Here are a few observations that my colleague Jim O'Donnell (Oceanography Professor at the University of Connecticut) and I, Arnaldo Valle-Levinson (Oceanography Professor at the University of Florida), have identified from the materials we have received from the National Park Service. These materials are related to the proposed modifications of the tidal-basin seawall and Potomac River seawall in the vicinity of the tidal basin.

Elevation line at proposed wall height (4.5 ft NAVD)

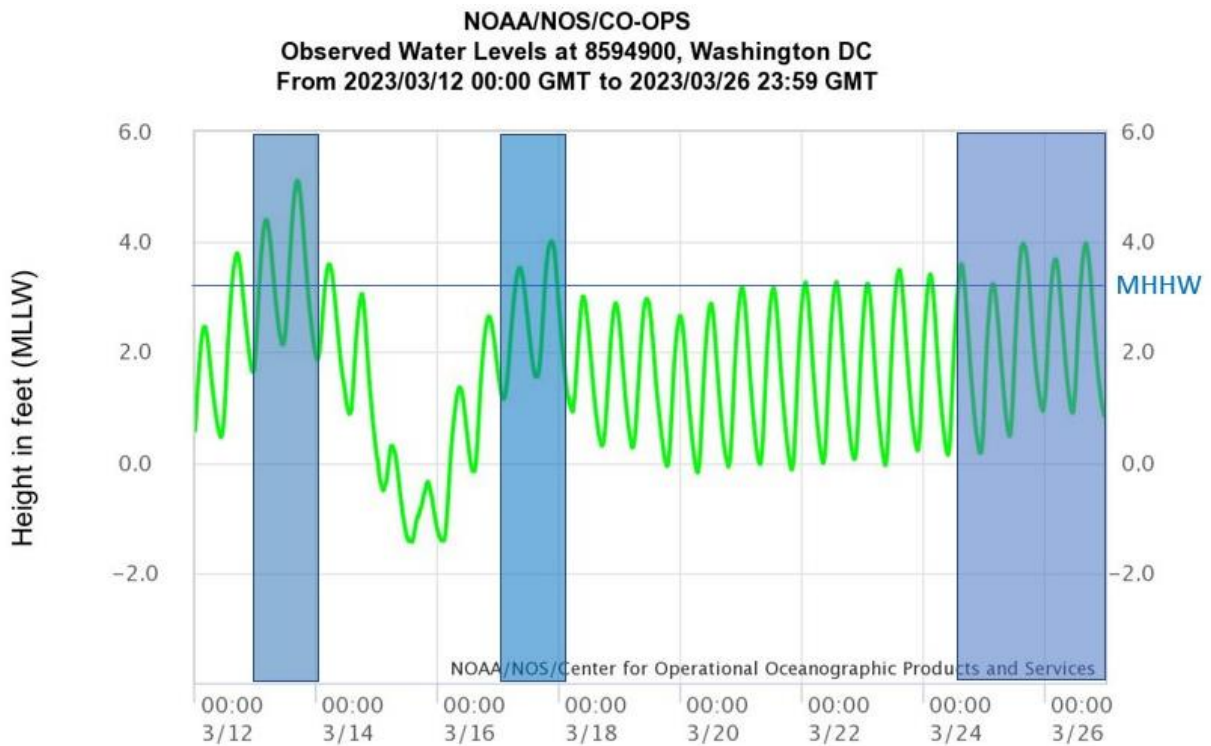
The plan will not prevent flooding of the path along the shore to the FDR memorial. This path flooded three times in March 2023 during the surge events that surpassed Mean High-High Water (see shaded periods in the Figure below).

The location of the contour at the elevation of the proposed wall (4.5 ft NAVD) is shown here,

This picture from Google Earth shows the estimated extent of the two vents in March 2023, and then in magenta the extent of the flooding that should be expected due to a 1/20 per year event (20-yr return). The thin green line is what should be the 1 in 20-yr event in 2050 (when sea level will be 1 ft higher). These events would surpass the proposed wall and cause extensive flooding.
